ADDENDUM | No. 2

Tea Law Enforcement Center

Project #: 23292.00.00

ISSUE DATE April 13, 2021

C-507R

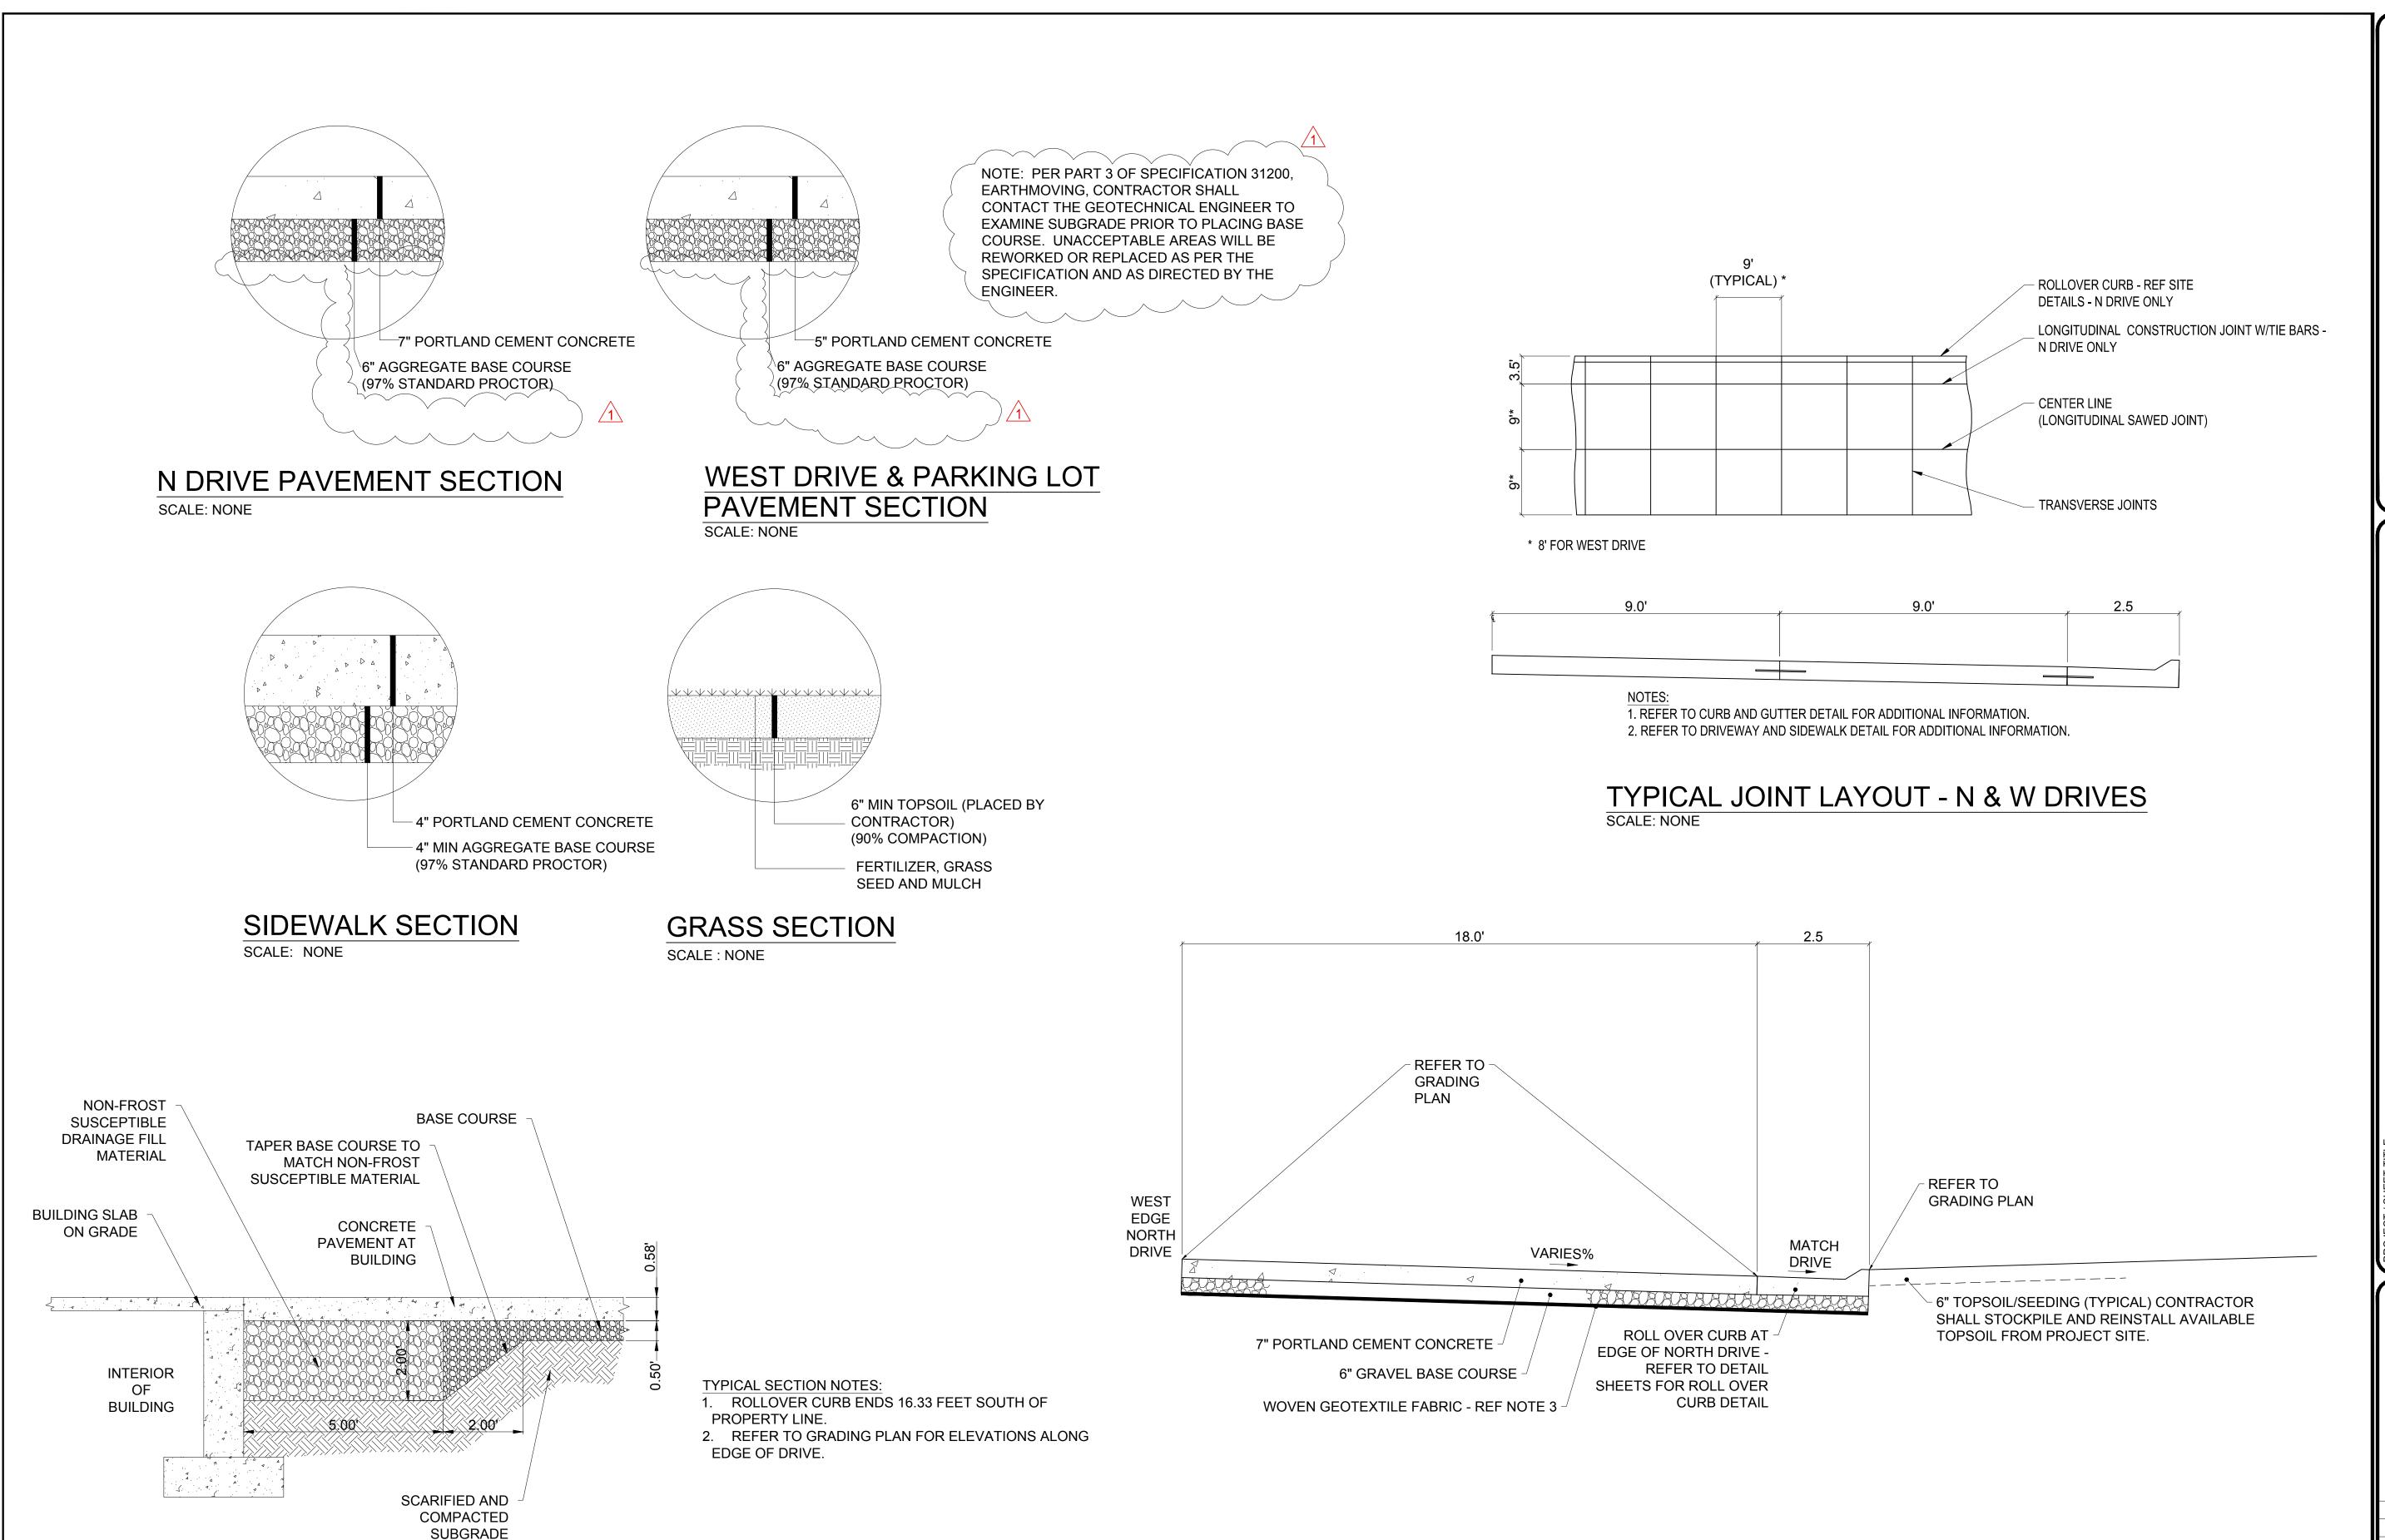
Drawing Sheet C-507 – Erosion Control Plan

Drawing Sheet C-507 in its entirety.

New Drawing Sheet C-507R – Erosion Control Plan – Refer to Attachments for new Drawing.

C-900R

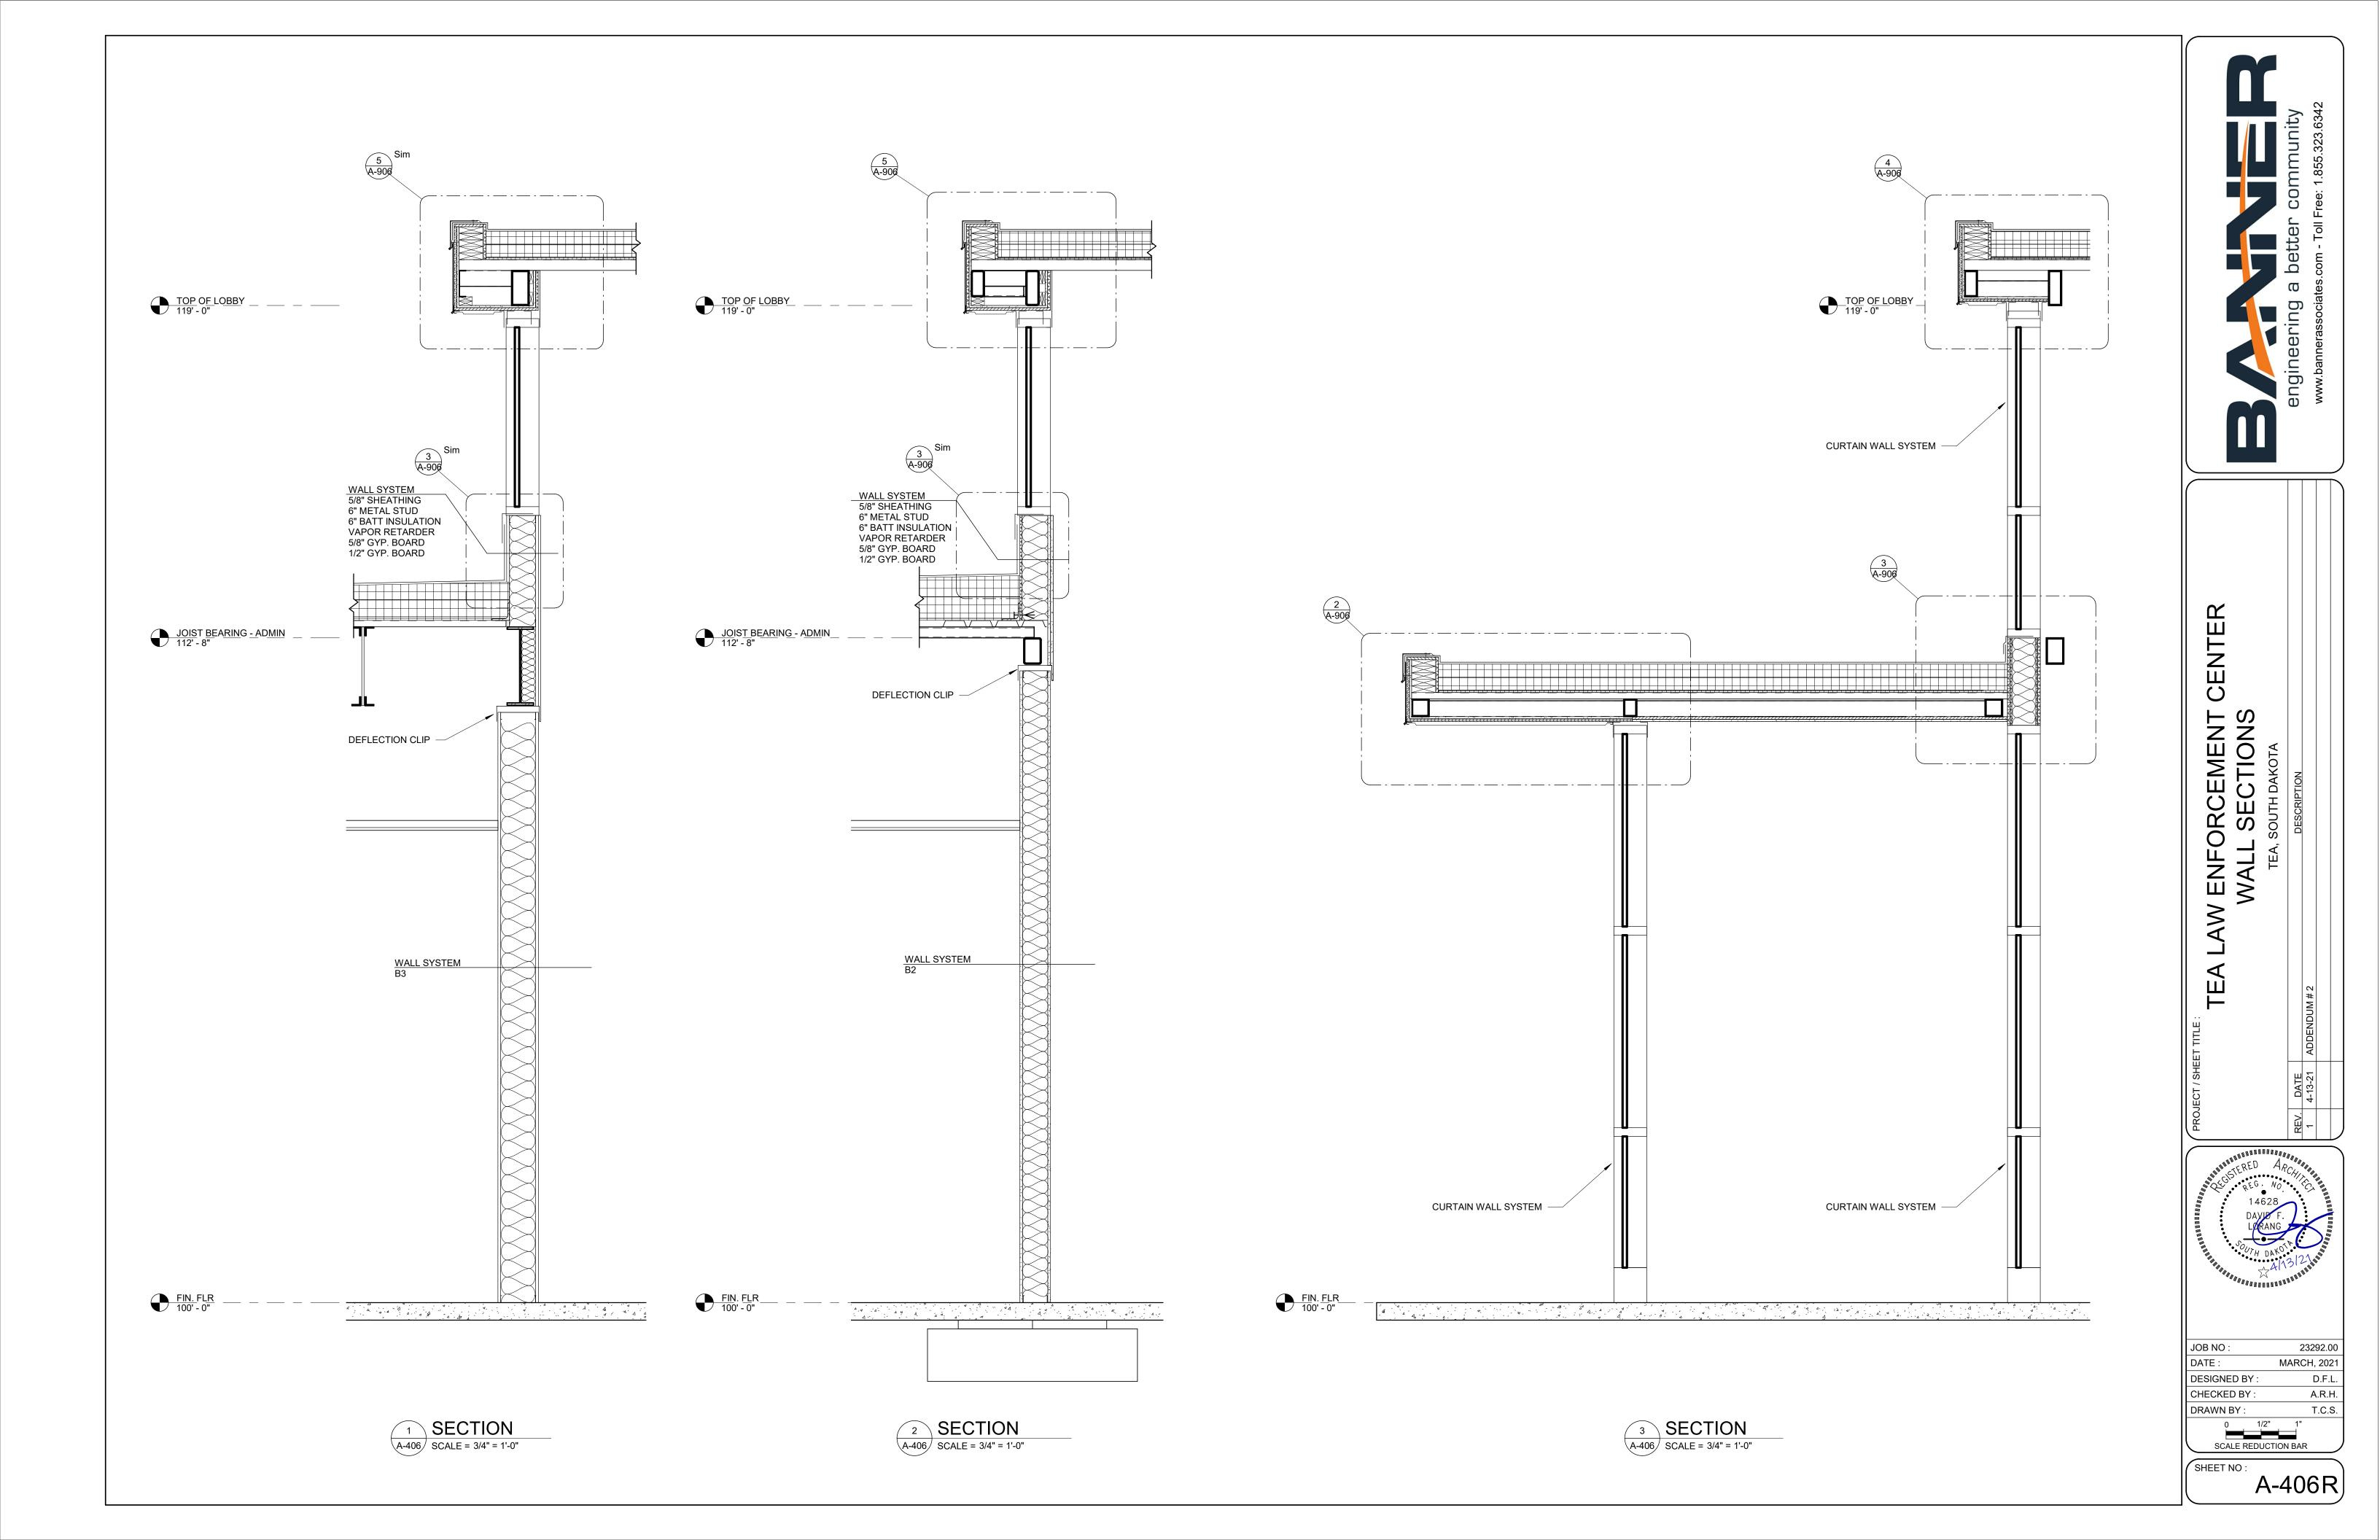
Drawing Sheet C-900 – Typical Sections

Drawing Sheet C-900 in its entirety.

New Drawing Sheet <u>C-900R – Typical Sections</u> – Refer to Attachments for new Drawing.
